Stanley Sidings, 101 Camley Street, Camden

South Block Envelope - Call outs

6022 S AL 0020 005

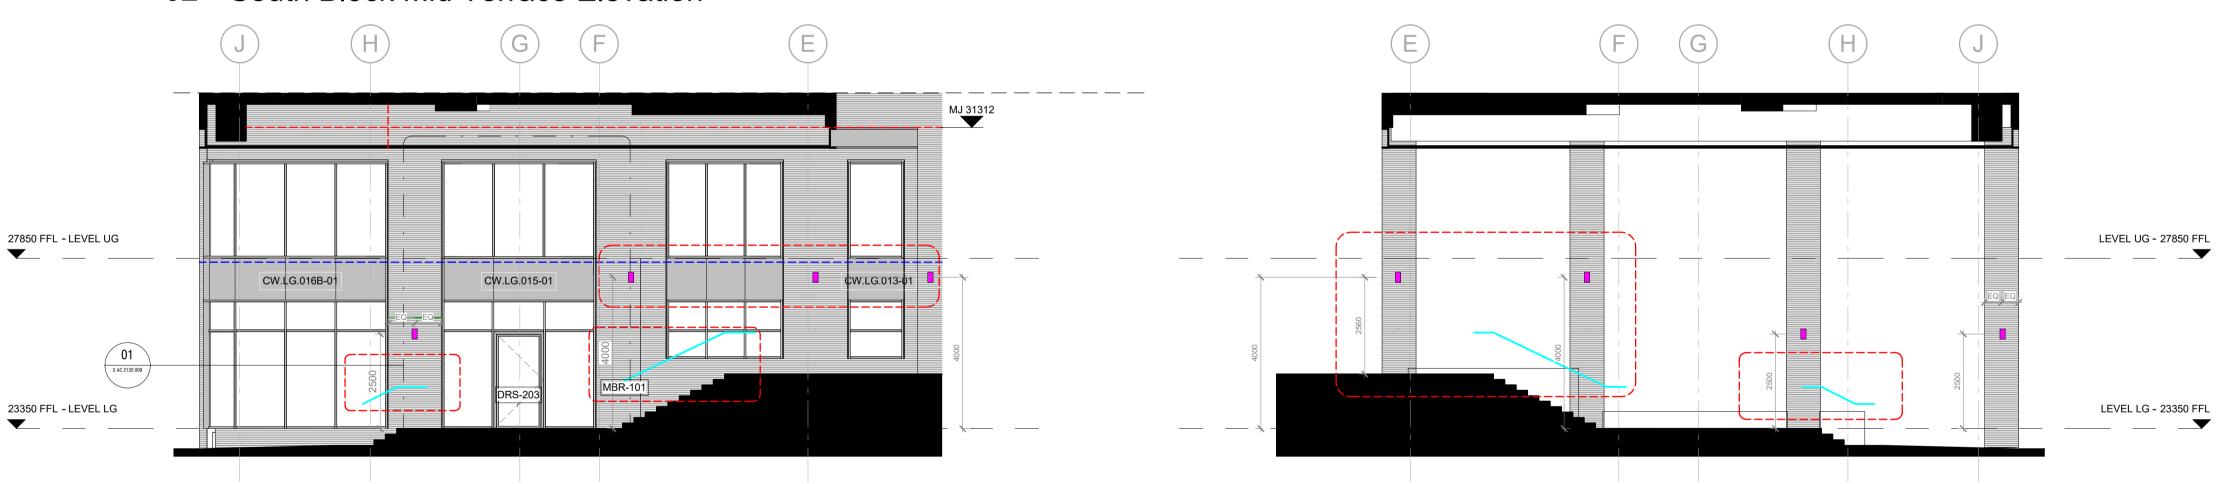
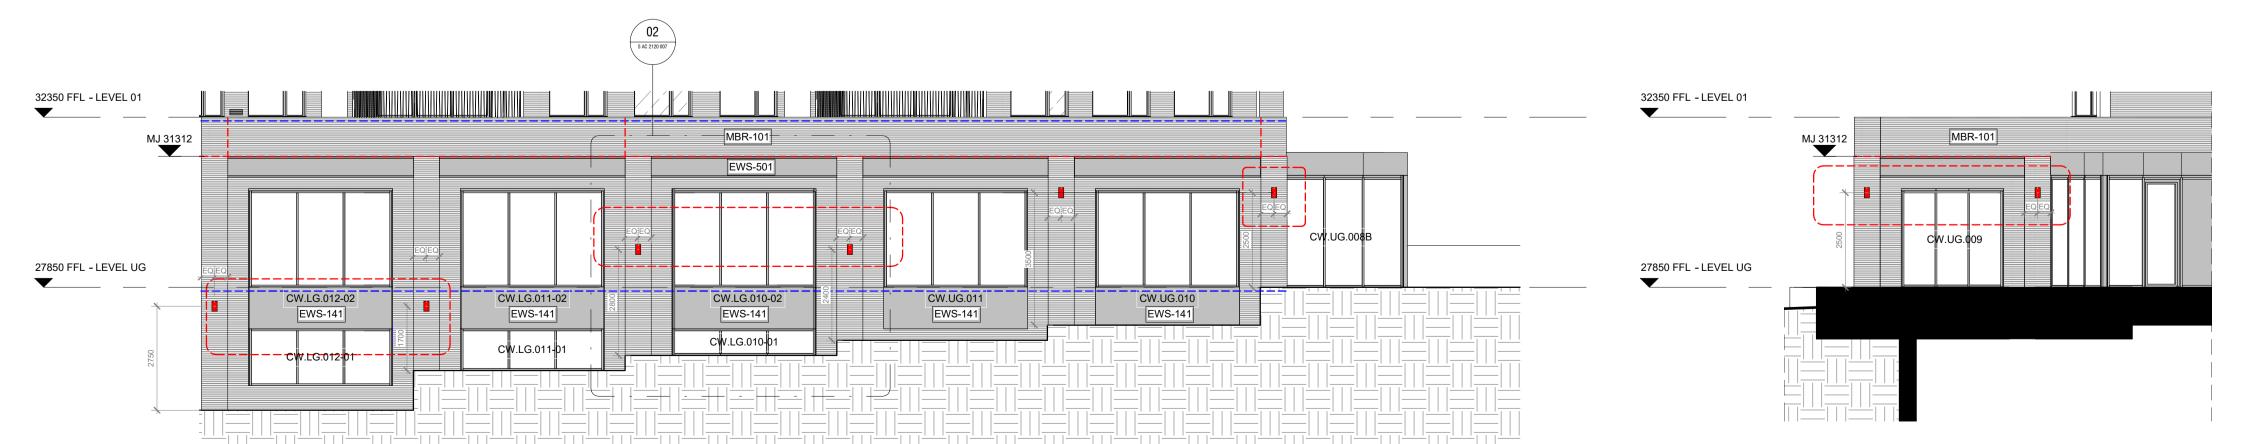
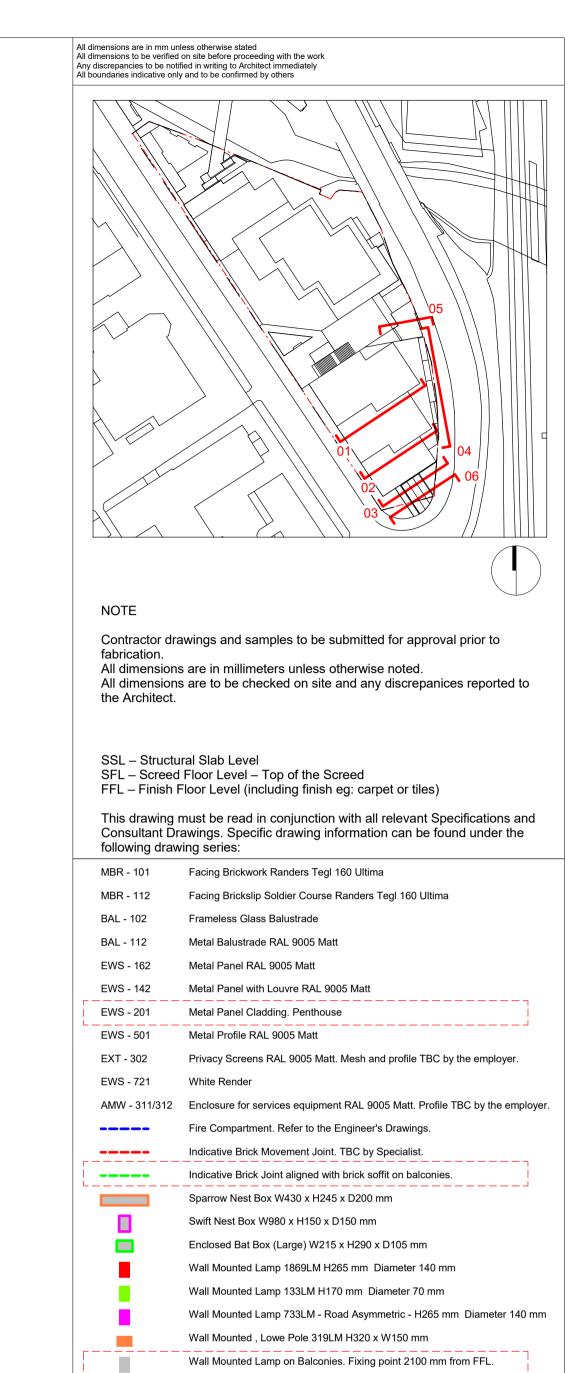
LED light strip integrated into metal handrails shown indicatively

clouds; LED strip incorporated on handrails, see revision clouds; bottom grilles have moved down, see revision clouds; MJ amended as per Client and Structural Engineer comments; Notes added on MJ in order to clarify

balconies revised as per client change; General updates in line with

real position; Brick Joints/Wall Lamps/RWP plates have been incorporated on Balconies; Key and Notes have been updated, see

04 07.02.19 Lights added/deleted/moved as per client comments, see revision

03 12.12.18 Movement joints added as per Walsh drawings; Sliding doors into
